BRUNSWICK STEAM ELECTRIC PLANT, UNIT 1 AND 2
NRC DOCKETS 50-325 AND 50-324
OPERATING LICENSES DPR-71 AND DPR-62
REQUEST FOR LICENSE AMENDMENTS
PRESSURE-TEMPERATURE LIMITS CURVES

TYPED TECHNICAL SPECIFICATION AND BASES PAGES - UNIT 2

MARKED-UP TECHNICAL SPECIFICATION AND BASES PAGES - UNIT 1

MARKED-UP TECHNICAL SPECIFICATION AND BASES PAGES - UNIT 2

FIGURE 3.4.6.1-3b
PRESSURE-TEMPERATURE LIMITS
REACTOR VESSEL

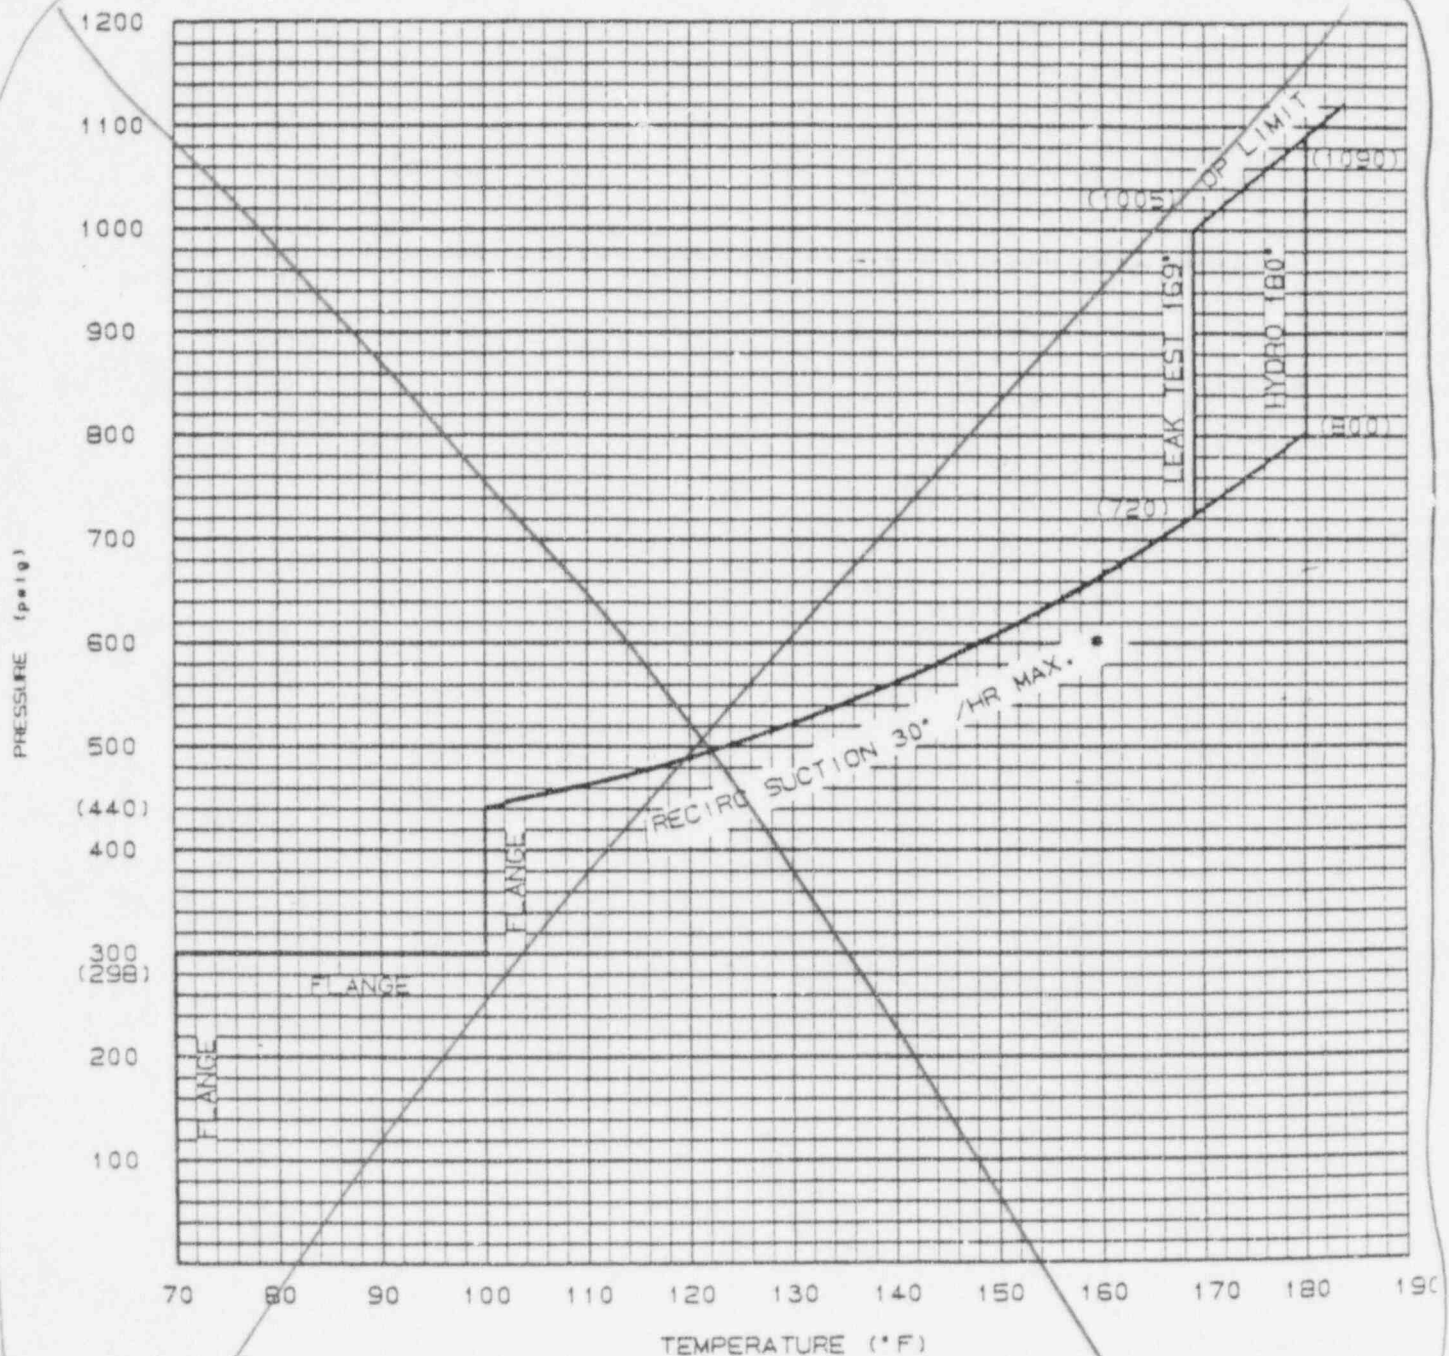
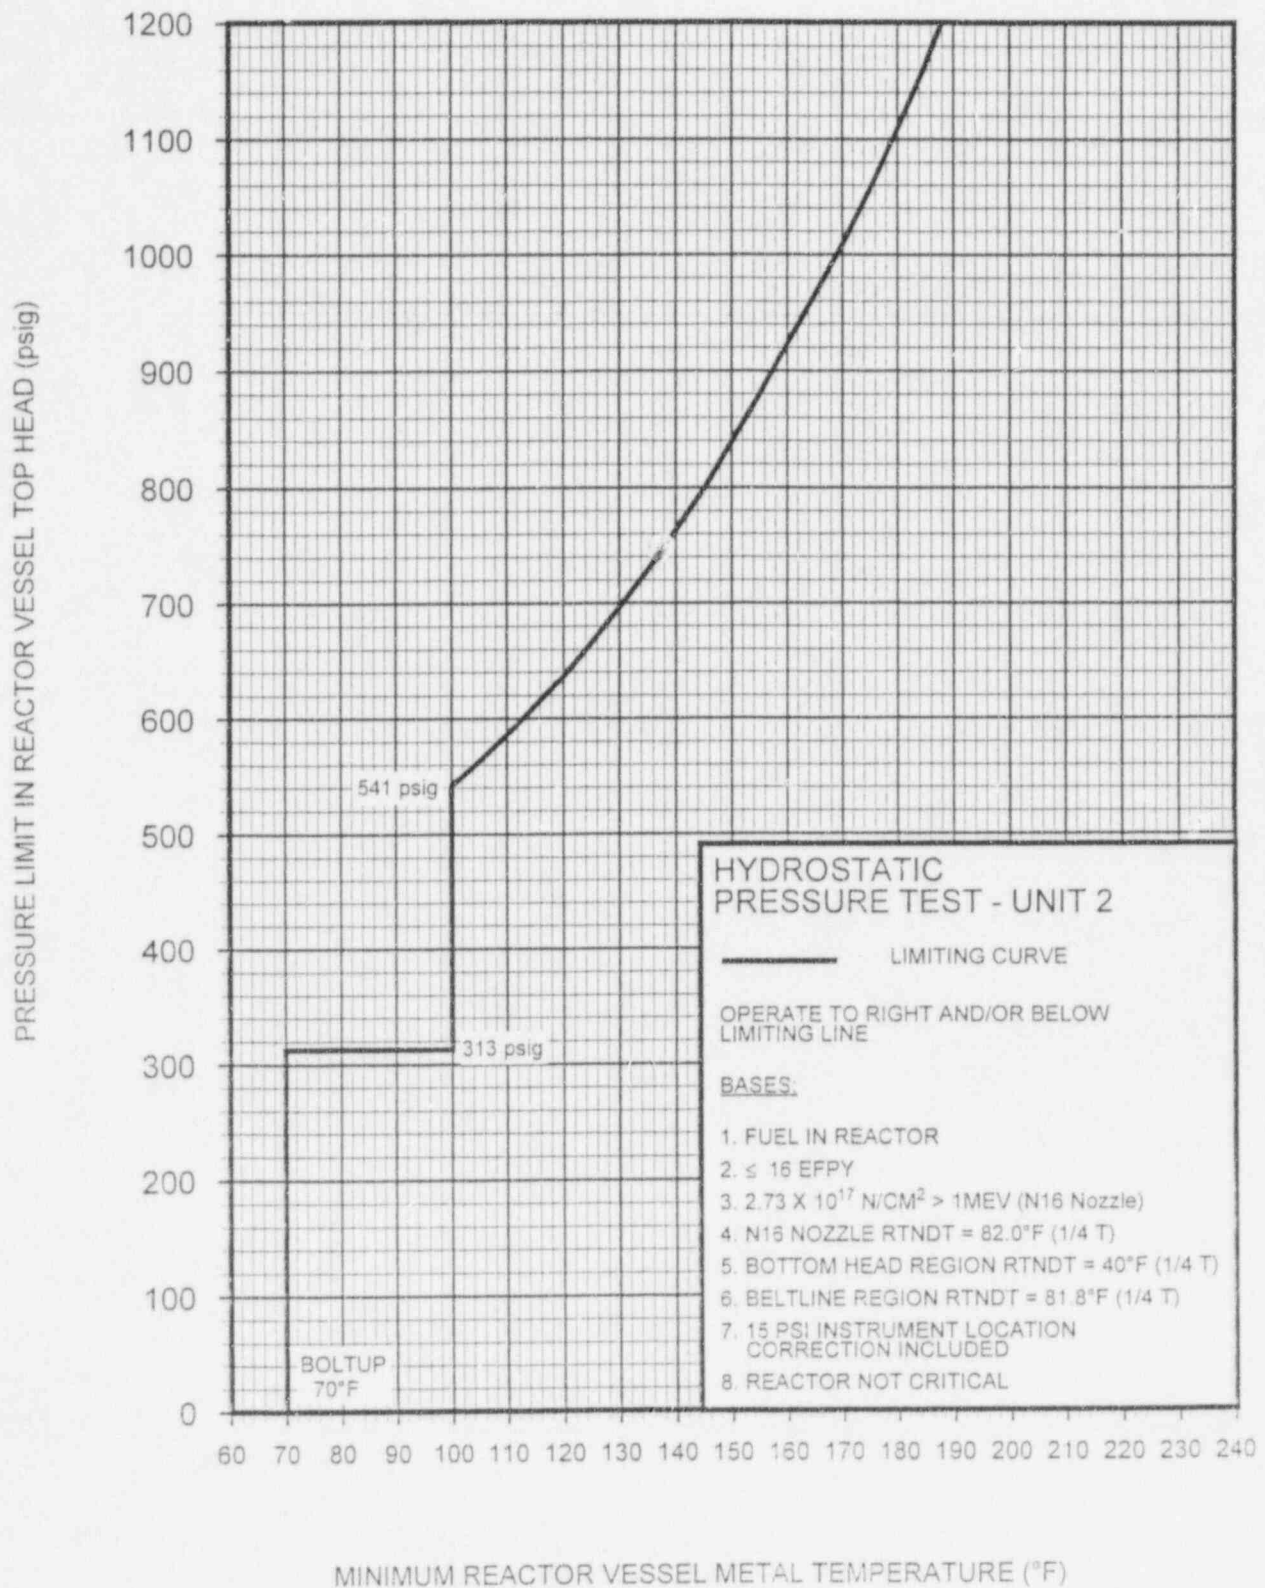
Insert 3.4.6.1-3b

Insert 3.4.6.1 - 3b

FIGURE 3.4.6.1-3c
PRESSURE-TEMPERATURE LIMITS
REACTOR VESSEL

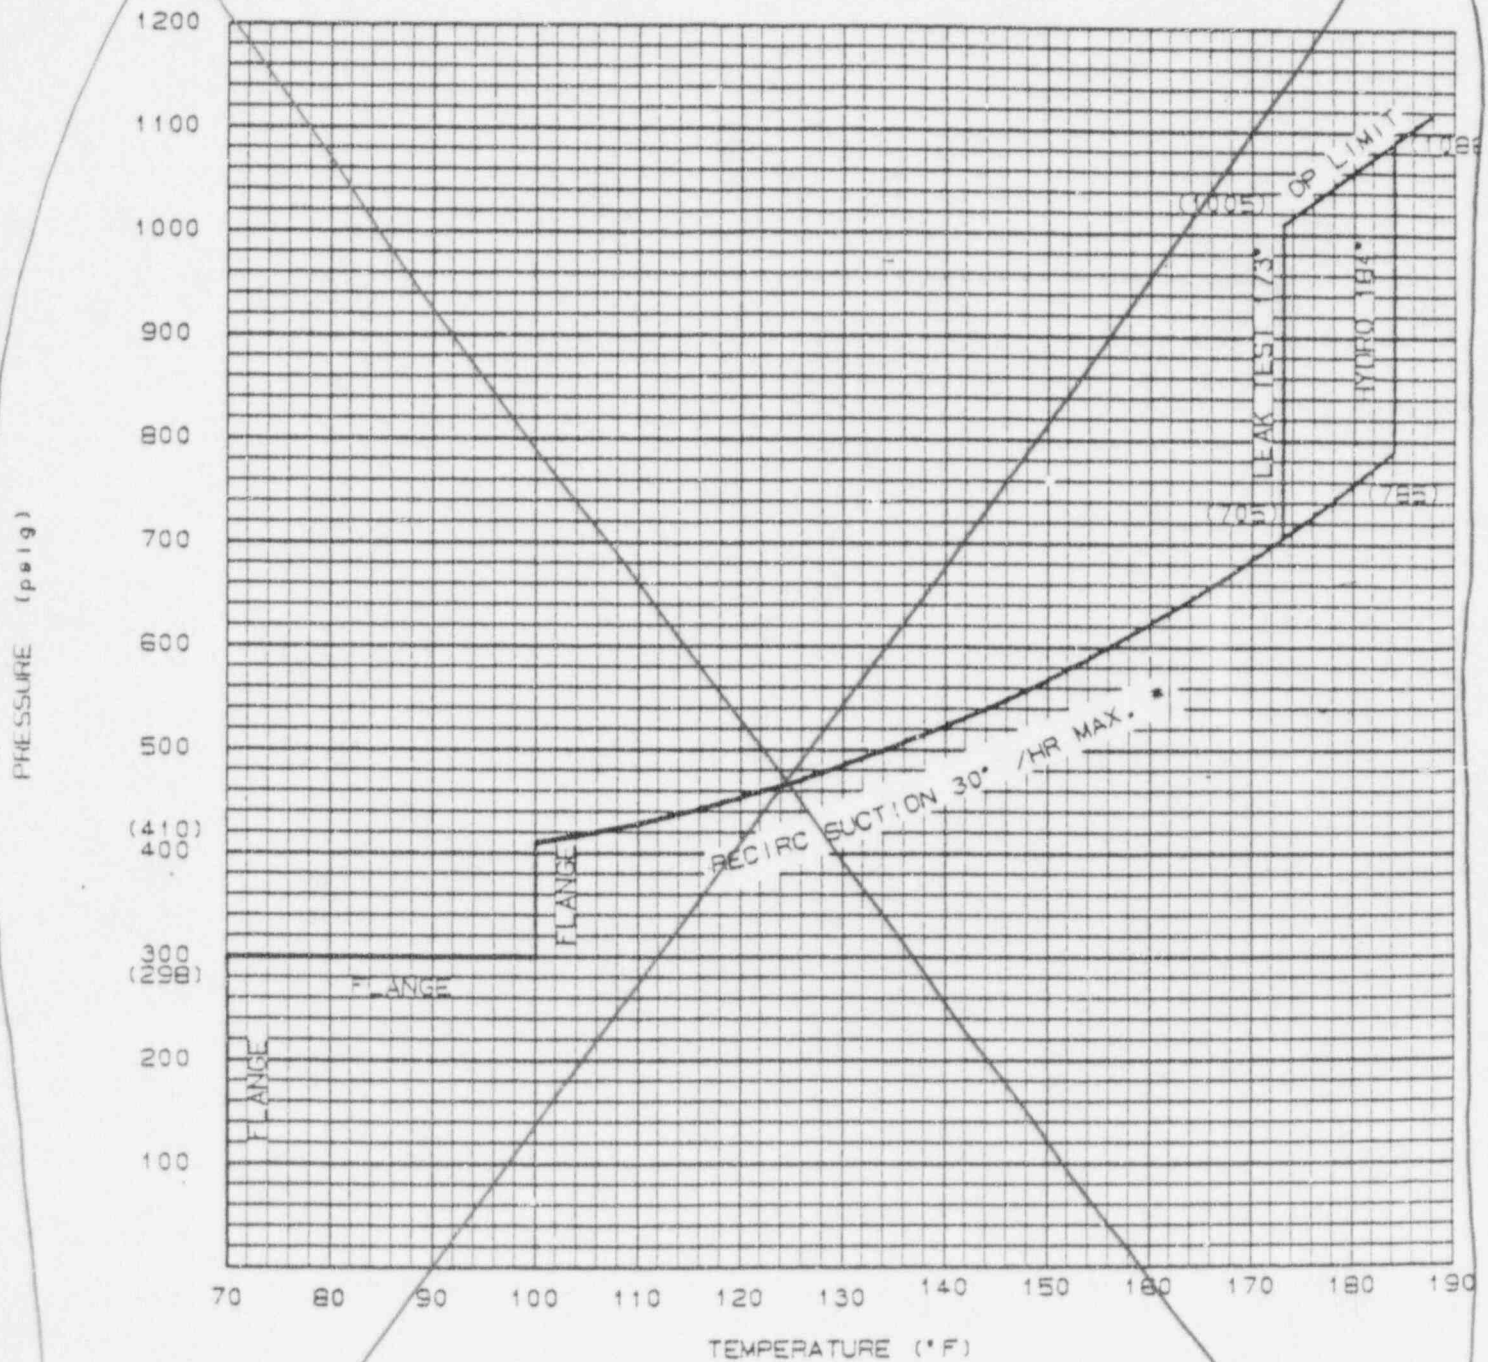
3.4.6.1 The reactor coolant system temperature and pressure shall be limited in accordance with the limit lines shown on (1) Figure 3.4.6.1-1 for heatup by non-nuclear means, cooldown following a nuclear shutdown, and low power PHYSICS TESTS; (2) Figure 3.4.6.1-2 for operations with a critical core other than low power PHYSICS TESTS or when the reactor vessel is vented; and (3) Figures 3.4.6.1-3a, 3.4.6.1-3b, ~~or 3.4.6.1-3c~~, as applicable for inservice hydrostatic or leak testing, with:

This page intentionally deleted.
